Office Action Summary	Application No. 09/871,199	Applicant(s) KAIN, JAMES M.	
	Examiner Joseph F. Edell	Art Unit 3636

DETAILED ACTION

Diagram A - Annotated Figure 1A of Lemmeyer et al.

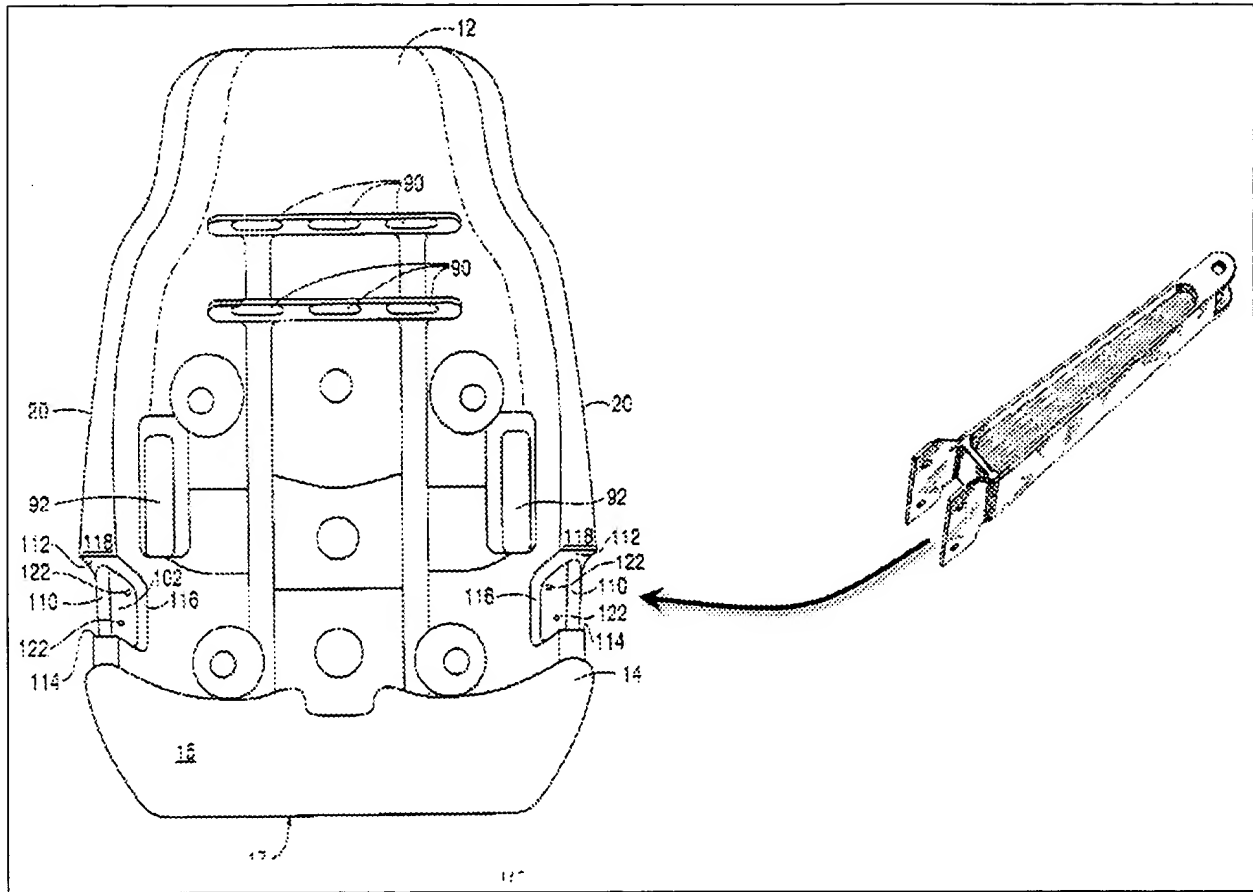
Applicant argues that rejection of claims 6-9, 11, 12, 25, and 27-29 as being unpatentable over Lemmeyer et al. in view of Marrujo because Marrujo fails to teach or suggest wings rising above the top surface of the arm. While the orientation of the wings in the Figures of Marrujo is not specified, Marrujo clearly teaches wings of a support mount extending away from the outer surfaces of the arm. Therefore, it would have been obvious to one of ordinary skill in the art at the time the invention was made to include wings on the armrest's support mount of Lemmeyer et al. Because of the horizontal orientation of the armrest of Lemmeyer et al. the modified wings of the support mount extend above and below the surfaces of the armrest. See Diagram A below to clarify the teachings of Lemmeyer et al. in view of Marrujo.

Diagram B - Annotated Figure 1A of Lemmeyer et al.

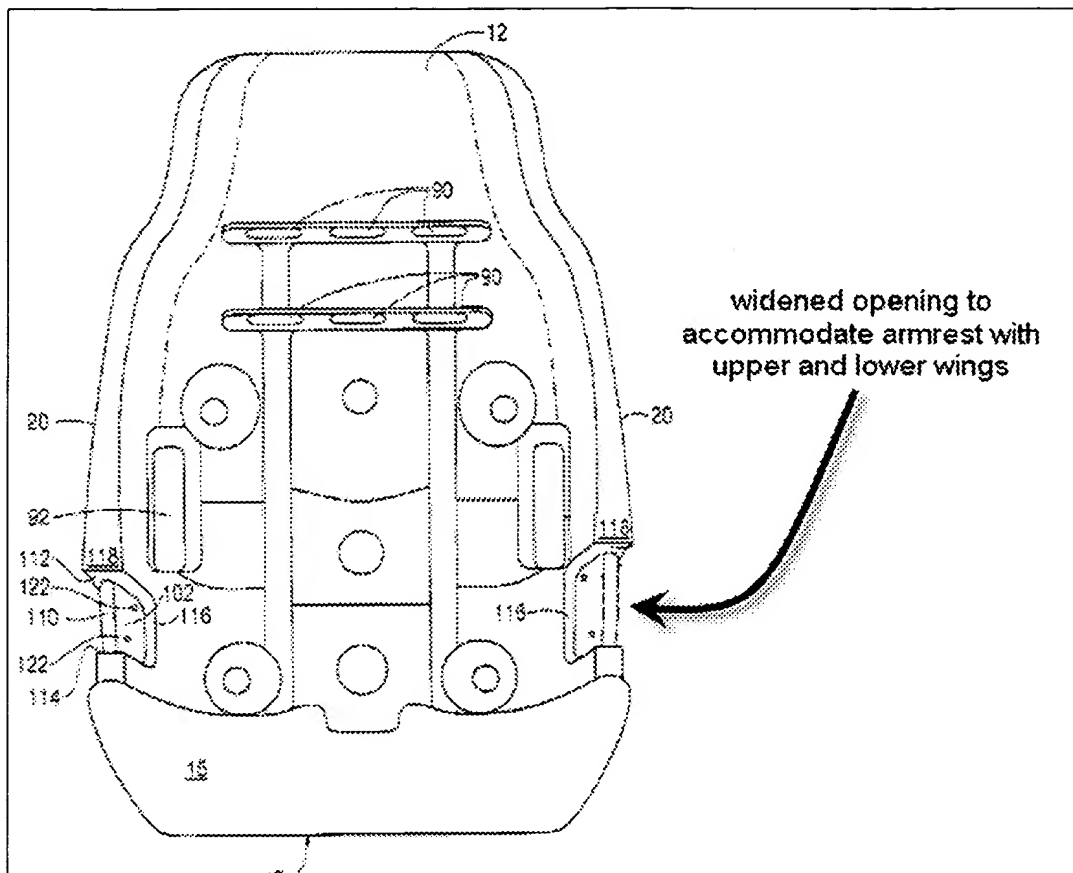
Next, Applicant argues that including wings on the armrest of Lemmeyer et al. would preclude the armrest from abutting upper and lower shelves 112,114 of the seat back ridge (shown in Fig. 1A of Lemmeyer et al.). This argument is unpersuasive for two reasons. First, it would have been obvious to one of ordinary skill in the art to widen the opening formed between the upper and lower shelves of Lemmeyer et al. to accommodate upper and lower wings extending from the armrest construction shown in Figure 1B. See Diagram B below.

Diagram C - Annotated Figure 1A of Lemmeyer et al. showing the support mount of Marrujo appended to the armrest shown in Figure 1B.

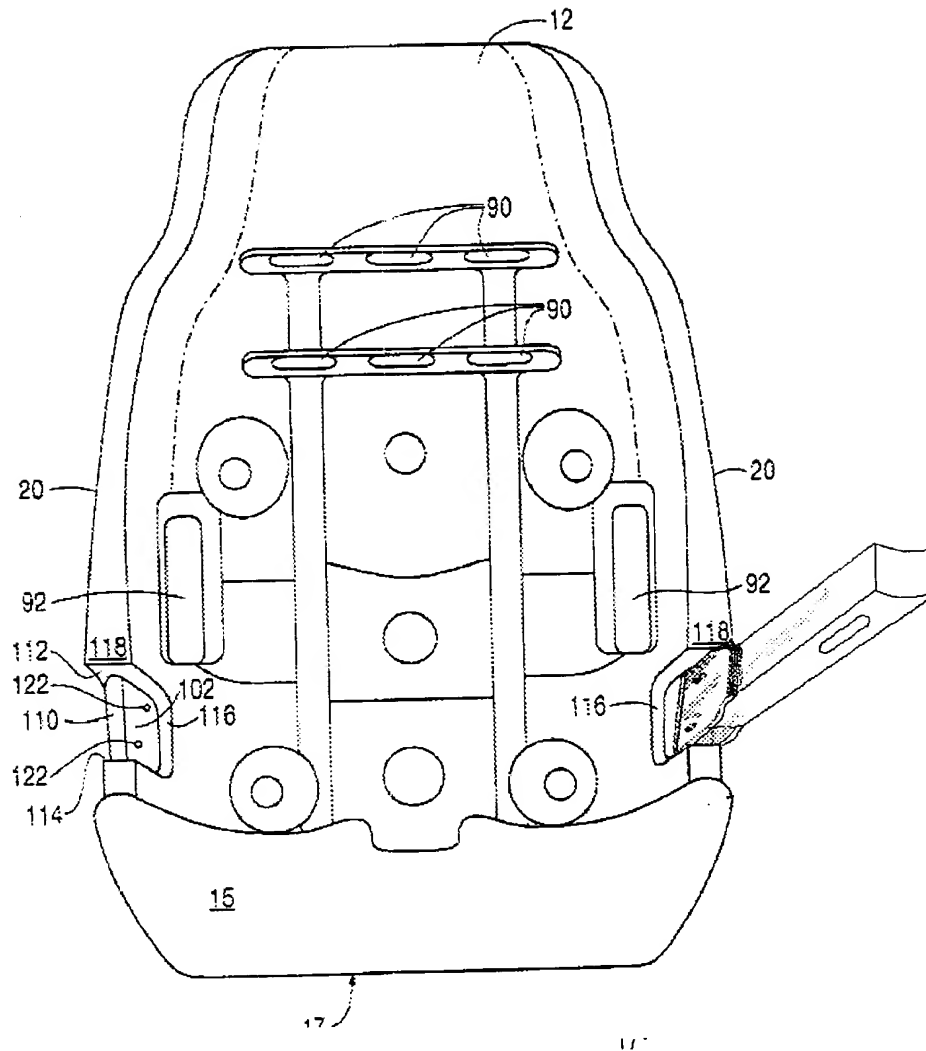
Alternatively, it would have been obvious to one of ordinary skill in the art to decrease the width of the armrest such that the support mount has upper and lower wings to extend above and below the armrest while coupling the tongue 110 between the upper and lower shelves 112,114. See Diagram C below.
